BDW Photo.

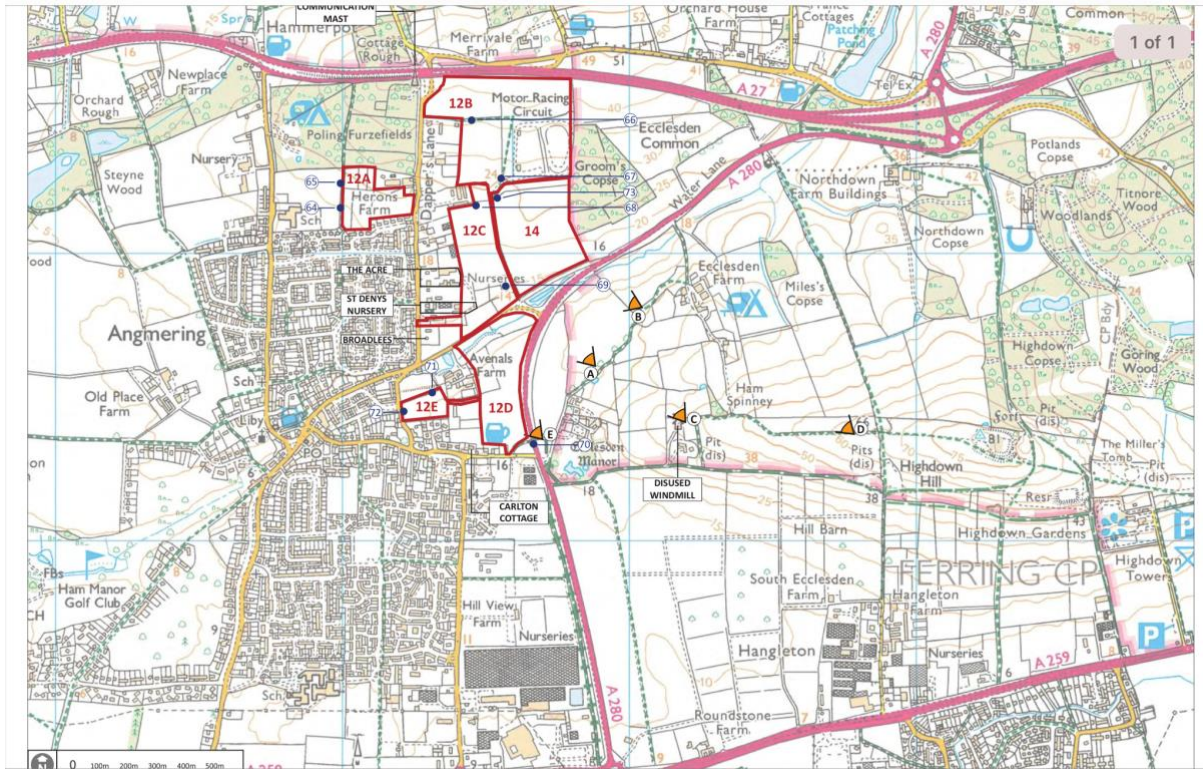
BDW are correct, the outline planning application and Parameter Plans were based on the 2017 Rydon LVIA. In their penultimate paragraph, they say . . . *"I hope you agree that the visual shows that the proposed development will comprise glimpses of roofs over existing vegetation . . ."*

New information submitted in BDW's LVIA as part of the detailed reserved matters application, also supported by their detailed technical drawings, shows the hedgerow to be between 3m and 4m high. Certainly not capable of achieving the claim above.

If you compare images of the site (below) taken from the bridge in November 2016 when Rydon were doing their infiltration, you can compare the height of the rig with the vegetation at the time Rydon's LVIA was written. The scaling of the dwellings in this visual has been made on the assumption the vegetation (hedgerow) was as described by Rydon's LVIA.

It is obvious the elevated views from the footbridge will give open views of the development, which we would all agree would be impossible to mitigate. Please see a photograph taken 31.01.21 to show the actual view.
